From: [REDACTED]
Sent: 26/11/2023 5:09:59 PM
To: Council Northernbeaches Mailbox
Cc: Michael Gencher; Karina Page; rory@roryamon.com.au
Subject: TRIMMED: Submission for application Mod2023/0554
Attachments: Objection to Boat Ramp to 316 Hudson Pde Clareville10046_Kim edit and removed 2 appendix.pdf;

In relation to the Modification of Development Consent DA2020/1762, granted for demolition works and construction of boatshed, ramp, slipway, jetty and steps (application number Mod2023/0554).

Image A: Google Earth screen shot approx. 2016

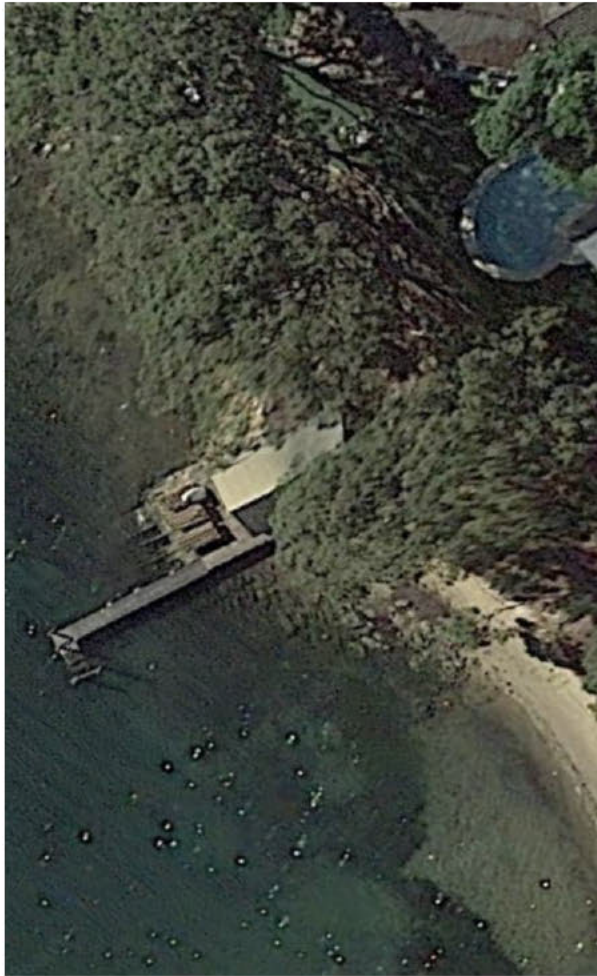
Image A shows the original boat house with jetty and jetty pylons.

The more recent Image B shows the footprint of the new boat house.

Image C: Overlay of Image A and Image

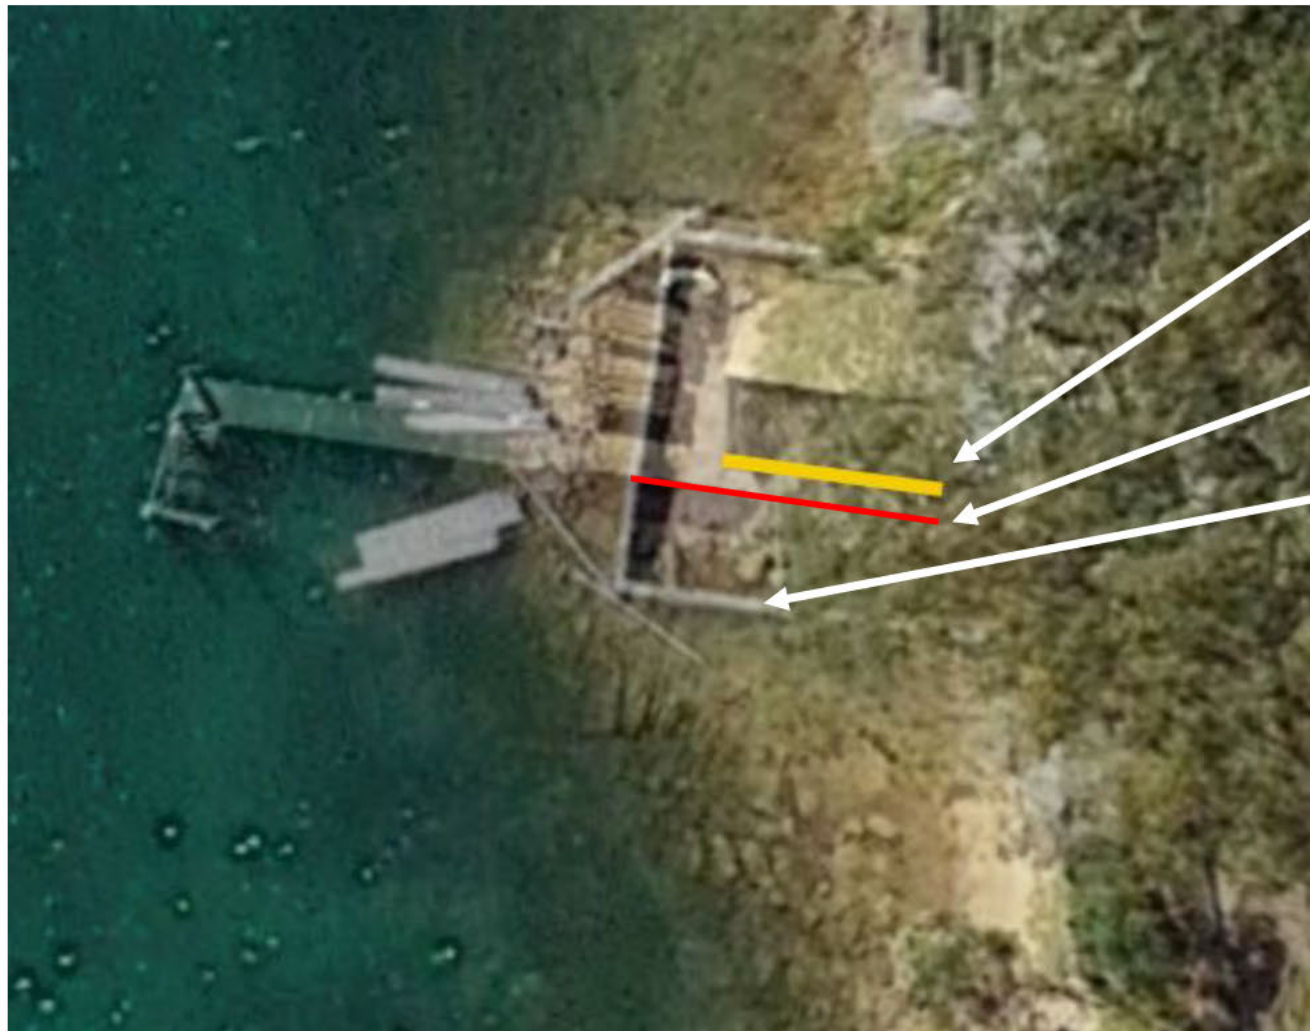
Approx. location of original sandstone wall of previous boat house.

Approx. Location of the original sandstone wall

Location of new southern Dintel wall, considerably further south than the original sandstone wall footprint

These images show the southern Dintel wall of the new boat house is significantly further south than the sandstone wall of the original boat house.

Image C is an overlay of Image A & B, in which you can see the new southern Dintel wall is now in line with the southern two jetty pylons, whereas the southern wall of the previous structure was set back and to the north from these pylons
